URBAN DESIGN COMMISSION APPLICATION

March 8, 2019,
Revised April 30, 2019
Submitted May 4, 2020
Revised September 23, 2020
Via email

City of Madison
Plan Commission Land Use Submittal

09/23/2020 UDC MINOR ALTERATION
DWG #	Drawing Title

A102.

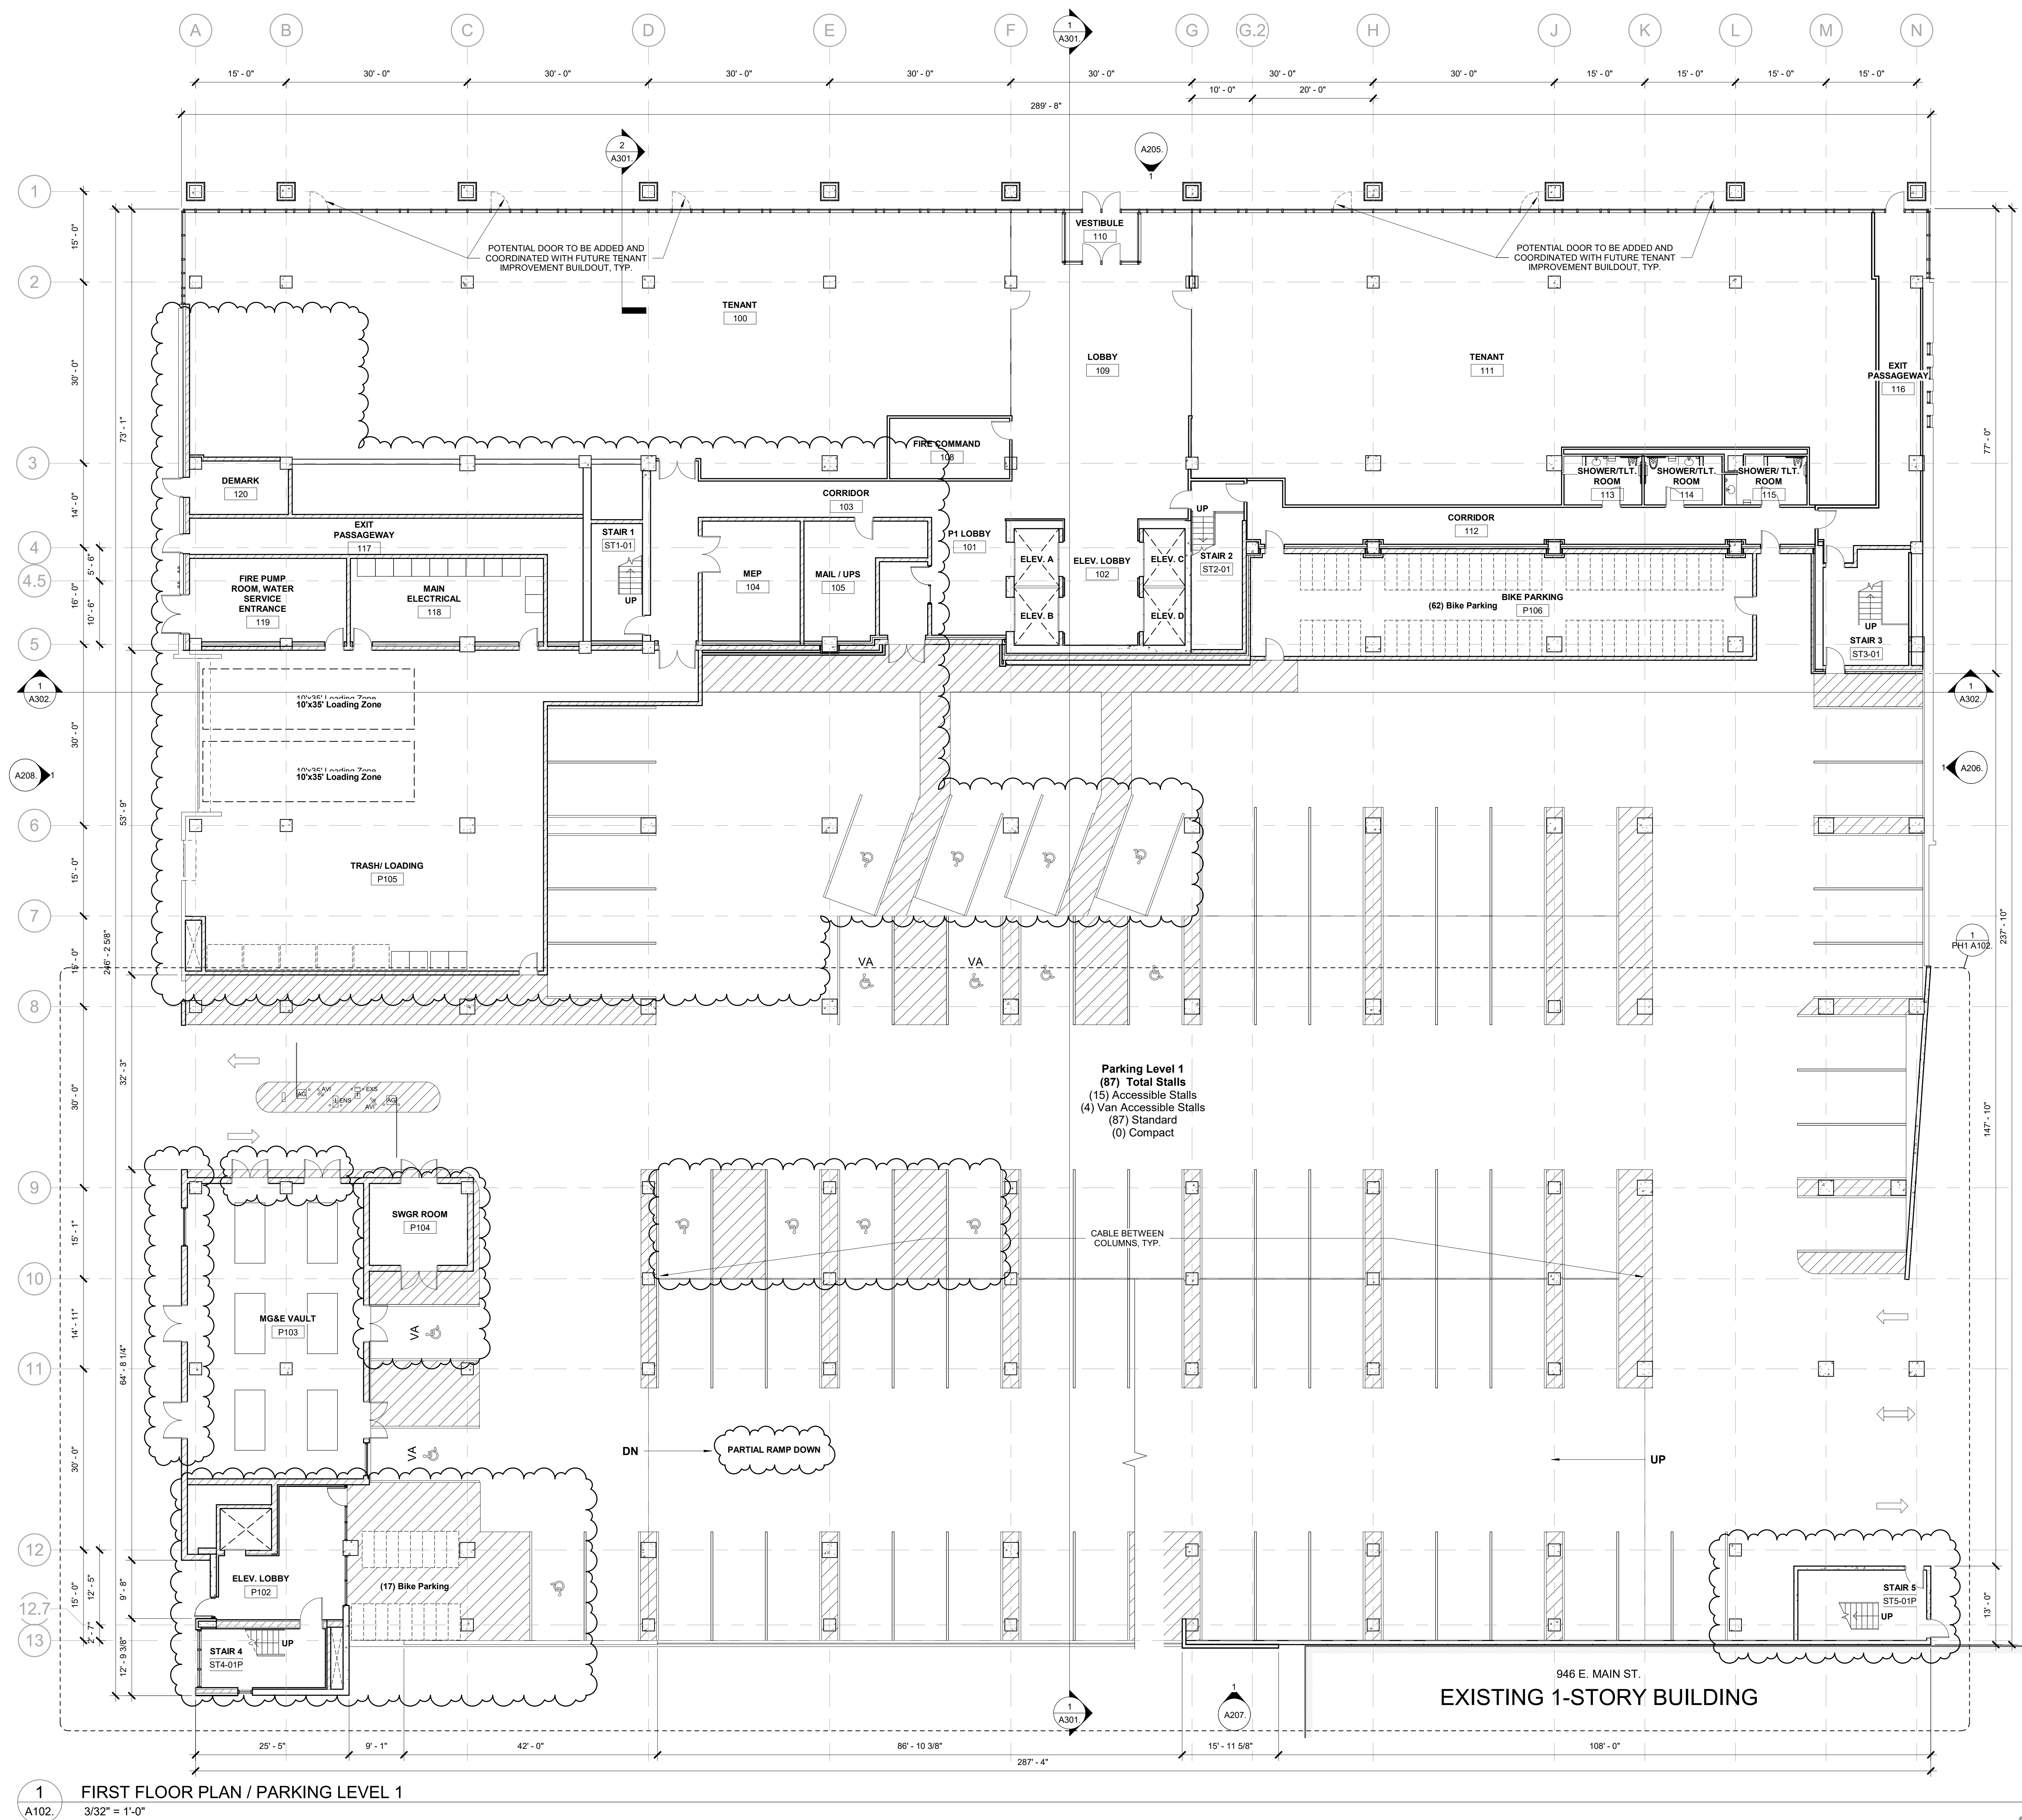
A design progression to the parking structure, submitted May 4, 2020, is limited to the southeast corner of the parking structure, where the floor plans are revised to remove the notch in the plan that created a distance separation from the existing Telephone Building. The plan revision adds a small amount of floor area to each ramp level and green roof, and parking spaces on each ramp level, increasing the stall count by 55 additional parking spaces.

- Basement of Parking Structure is eliminated.
- Parking Structure floors P3, P4 and P5 are extended towards E Washington. (no additional height or bulk)
- Number of stalls went from 626 to 718. (addition of 92)
- Phase 1/ phase 2 concept for completing the construction.
- Exterior design of the Phase 1 Parking Structure, materials, modified. (reviewed by UDC)
- Exterior design of 929 East Washington façade, modified very minimally to go from office use to parking use, but same materials and look, with frosted glass to screen parking floors.
- Area of 929 went from approximate 252,000 SF to 208,000. (44,000 SF less- loss of area on 2 and 3)

A203.

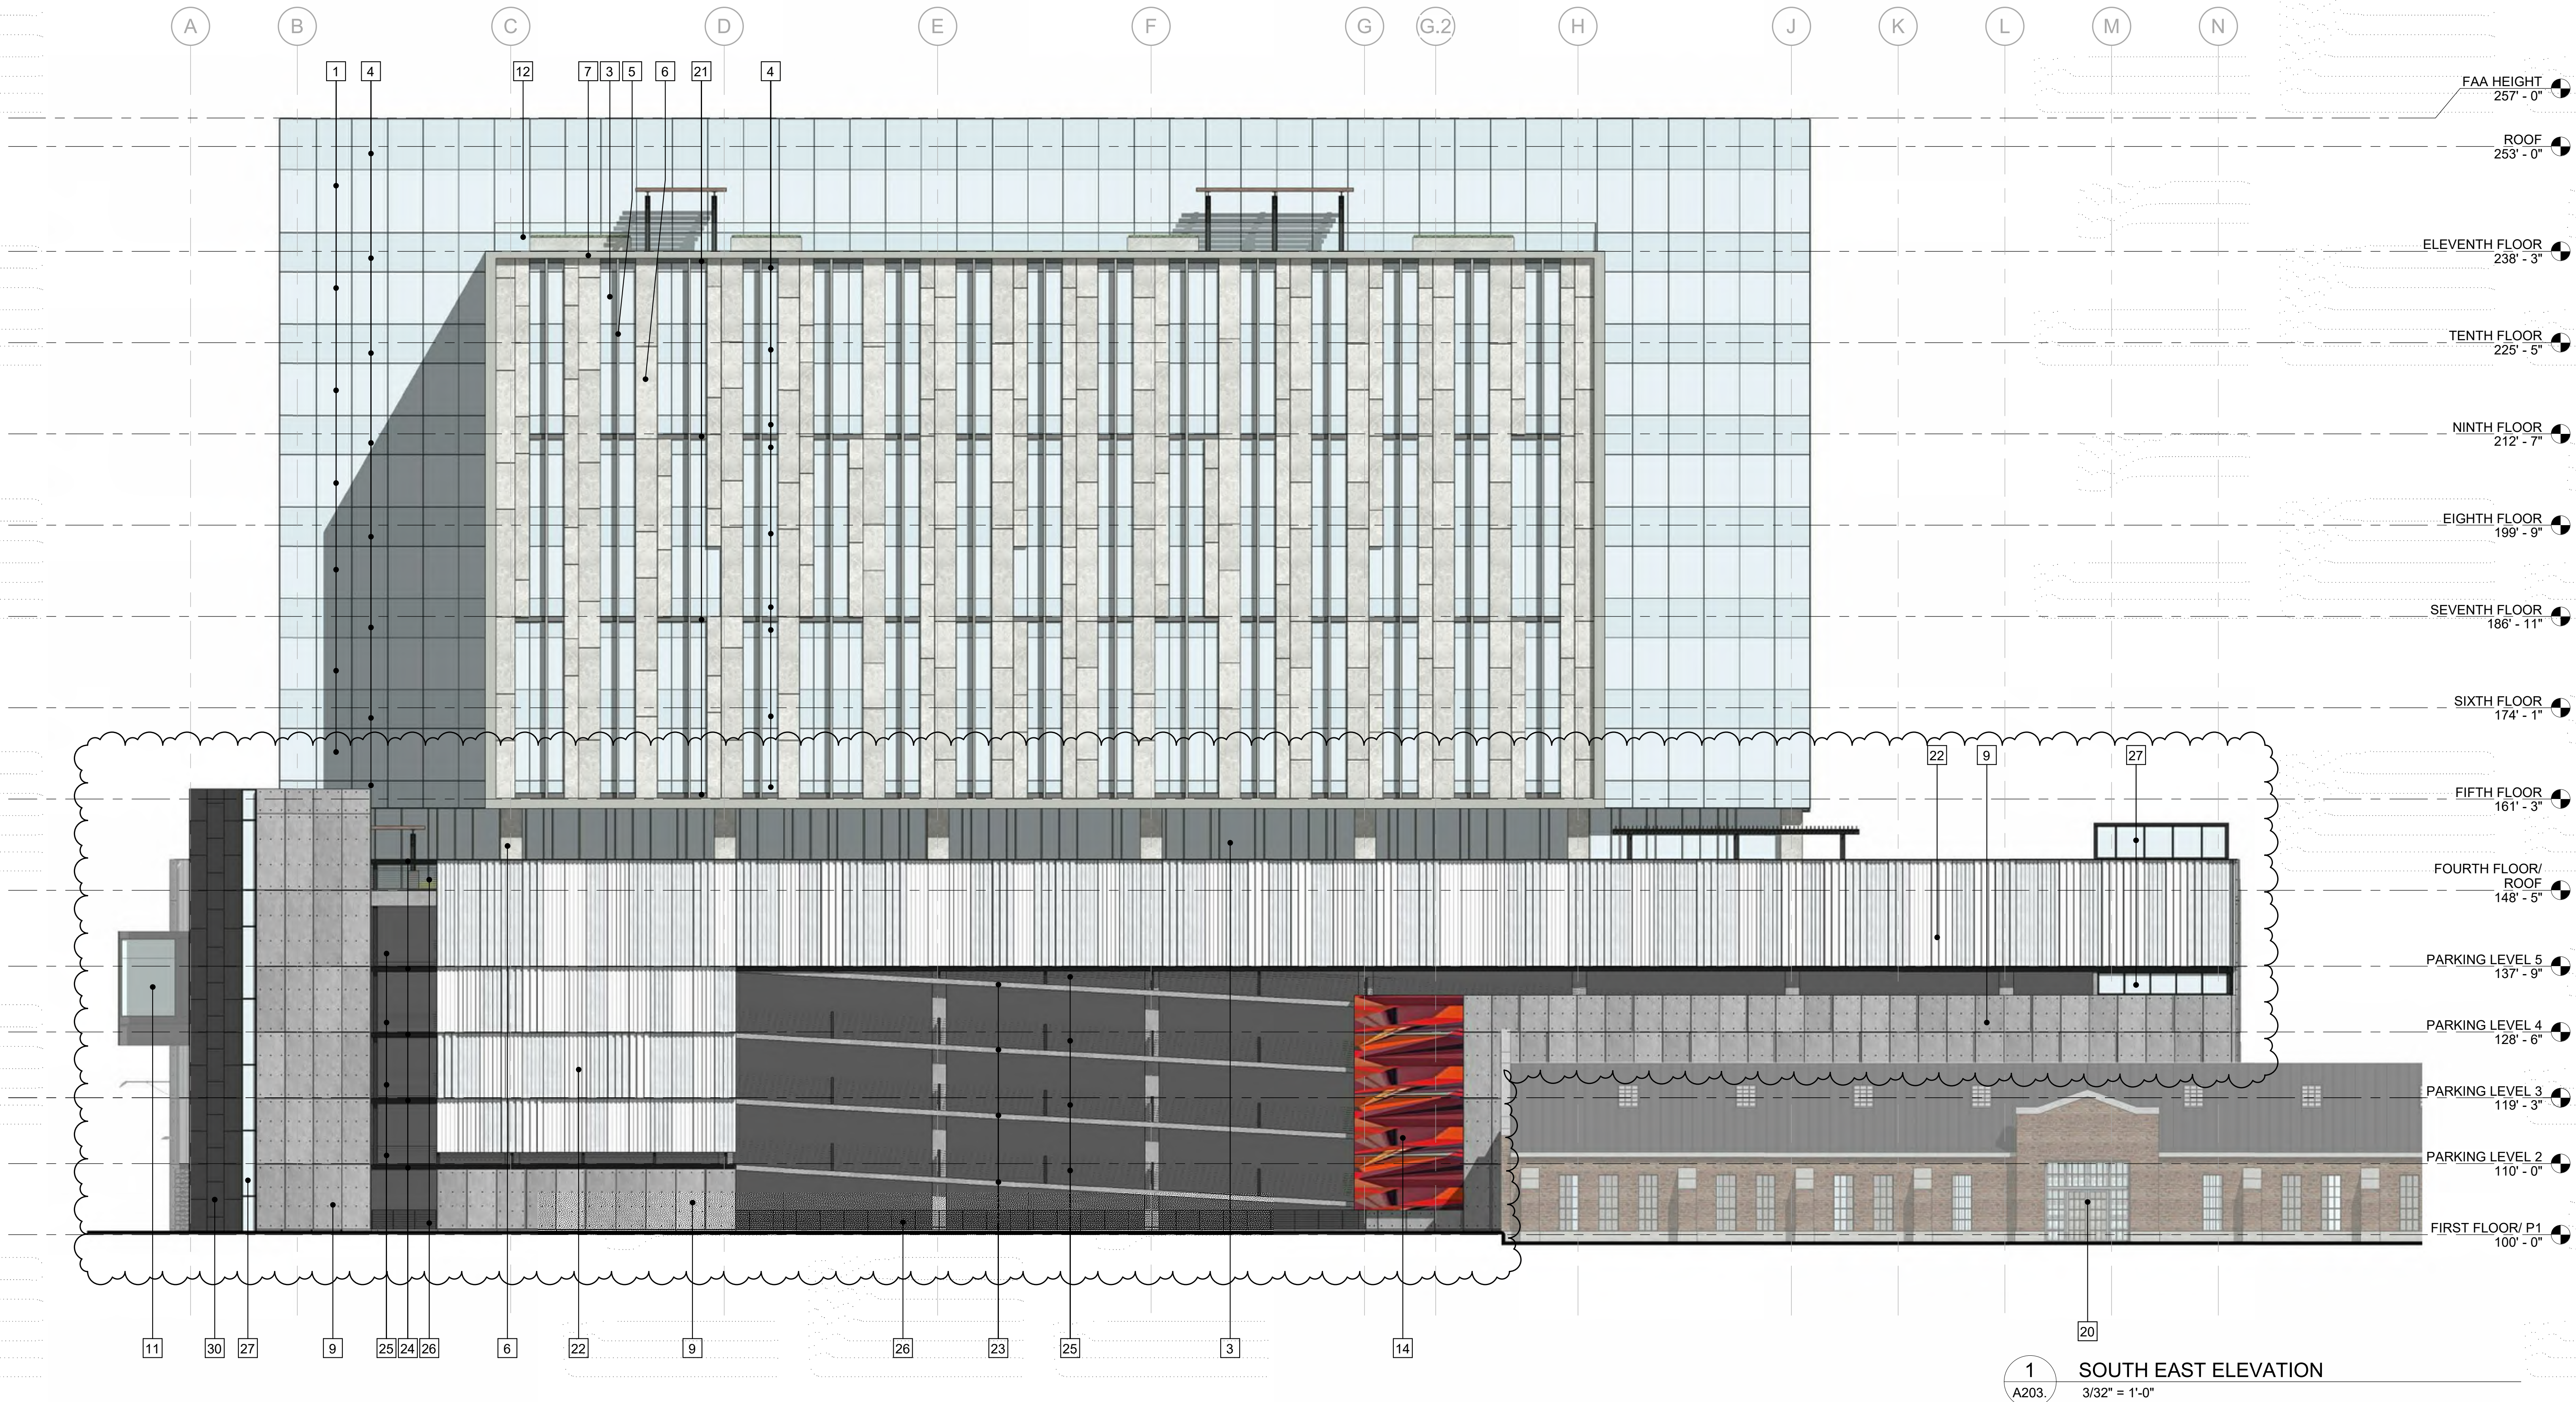
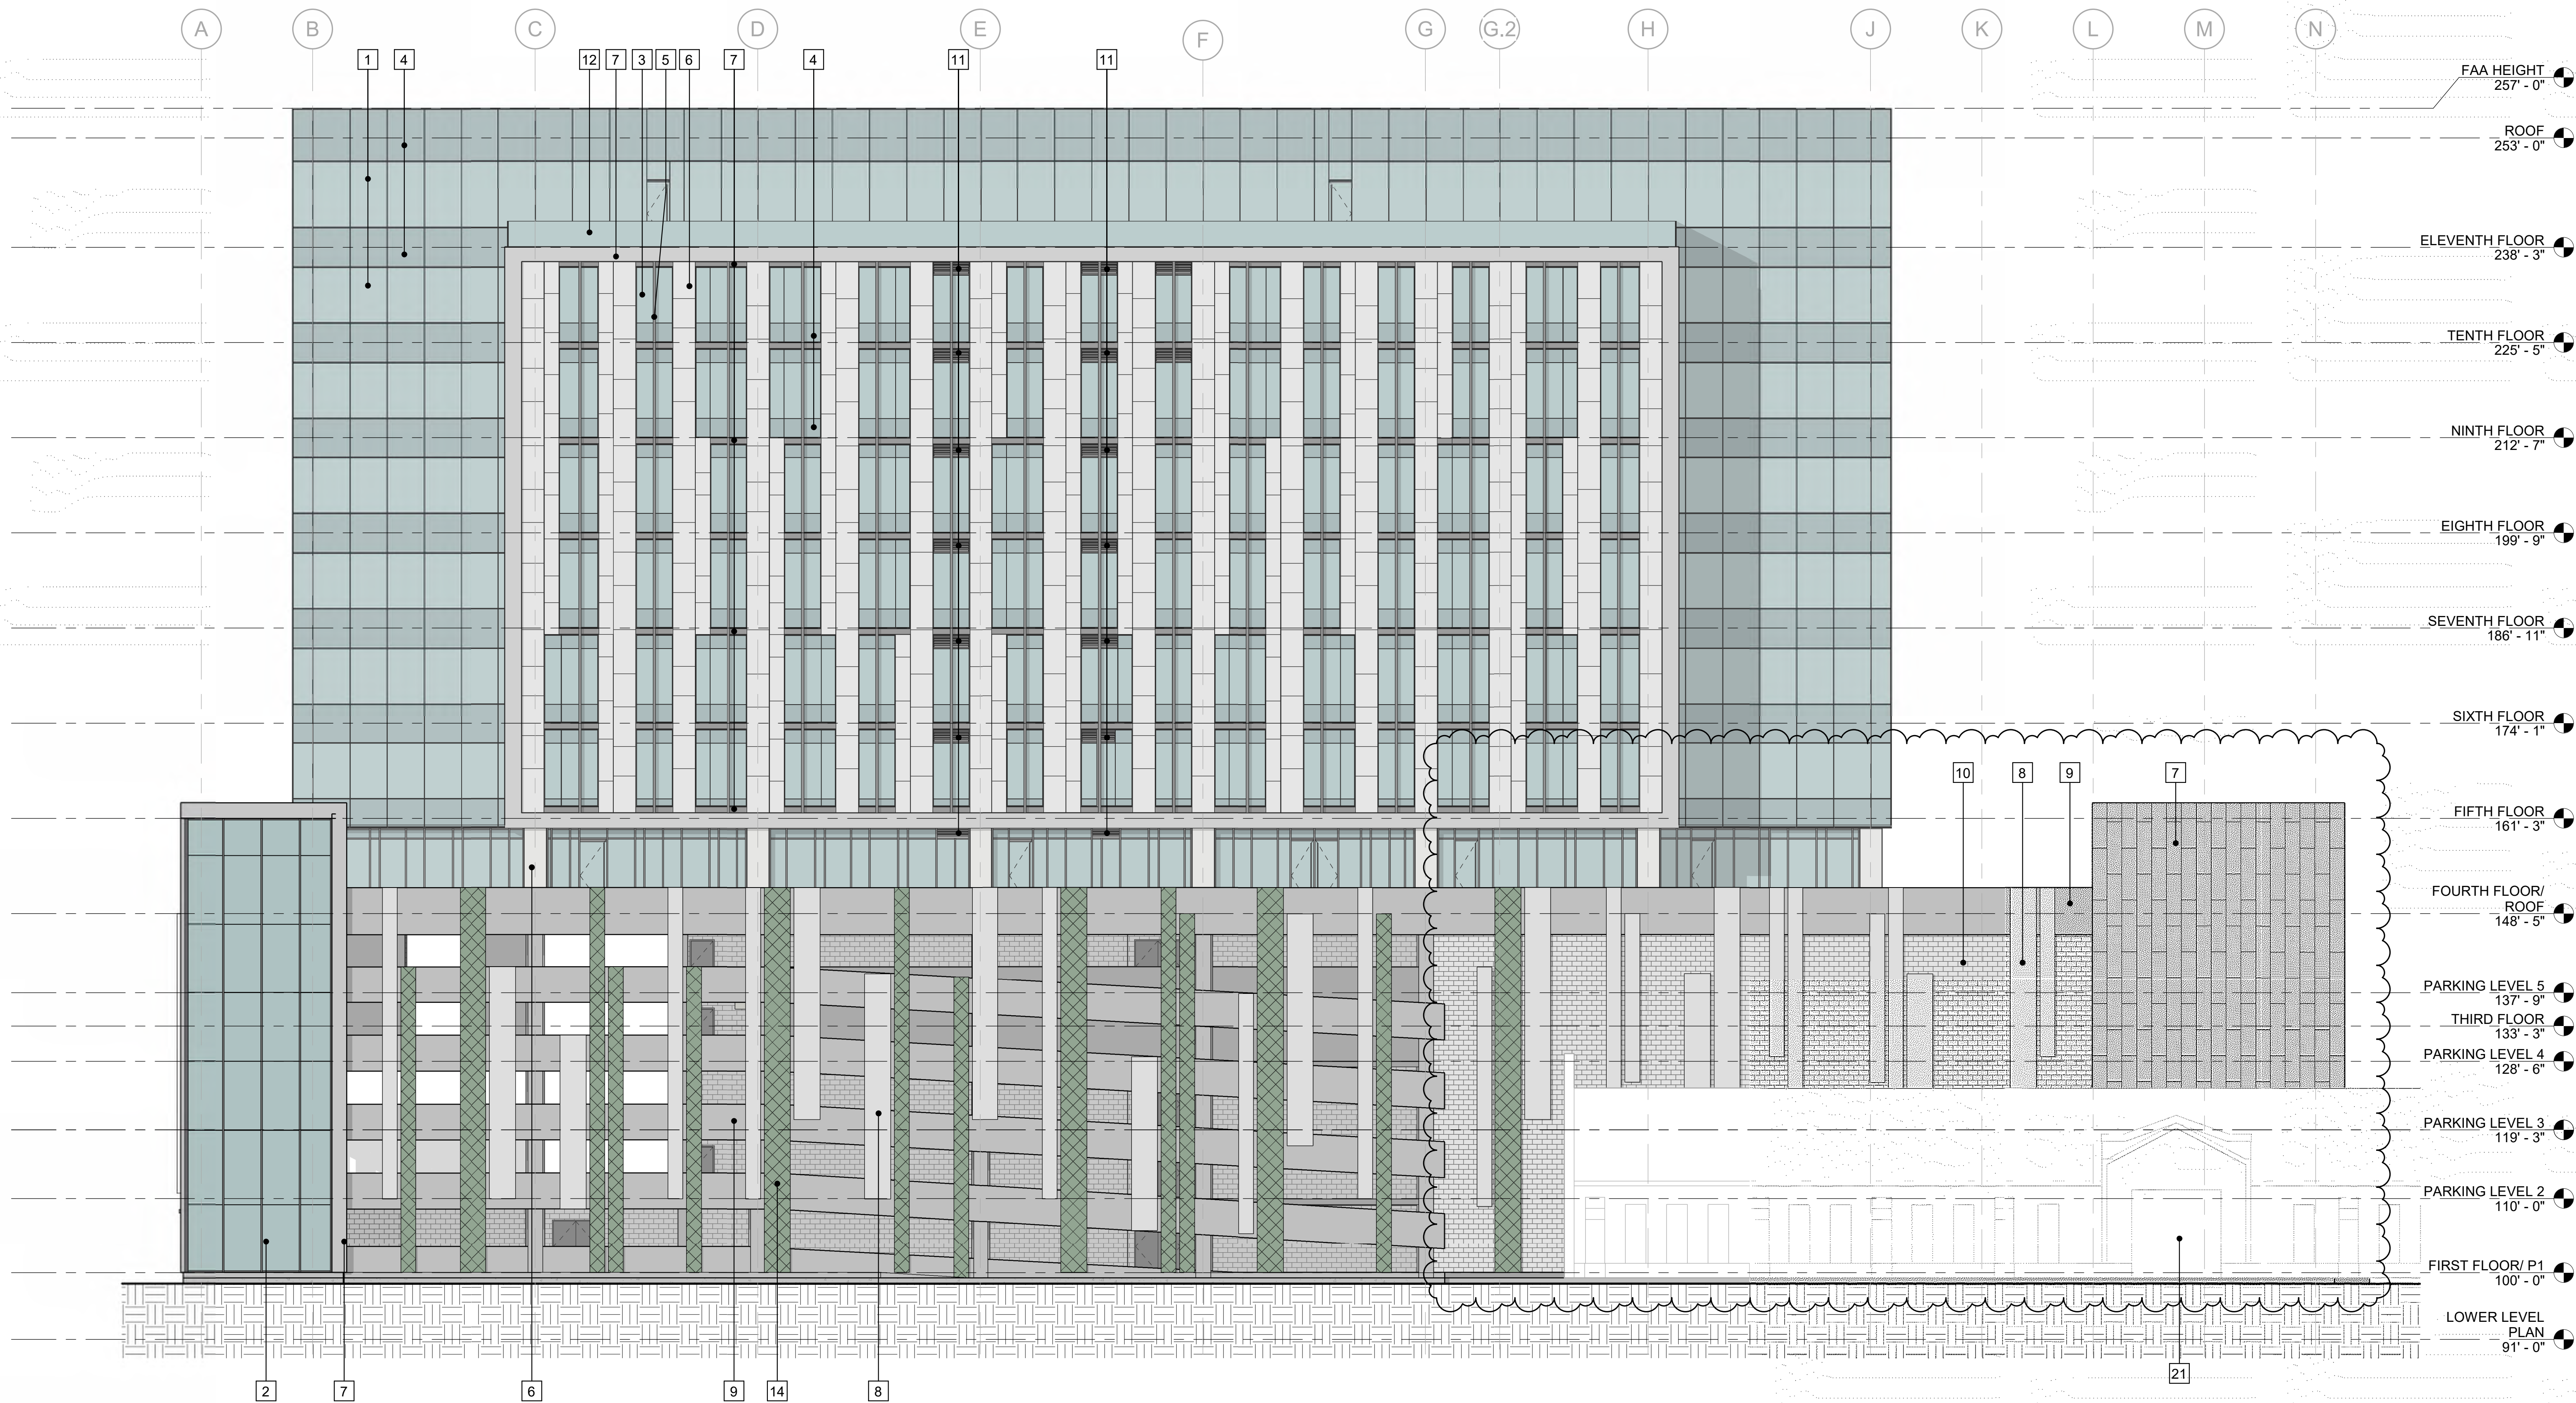
The revised design also includes a full height exit stair in the southeast corner to improve ramp egress design. The Developer is now considering potential development of the existing Telephone Building as a mixed used residential apartment building as an addition to the 929 Est Washing Avenue Project. The exit stair provides connection to the parking ramp at some ramp levels for convenient connection to parking, and resident egress to the street.
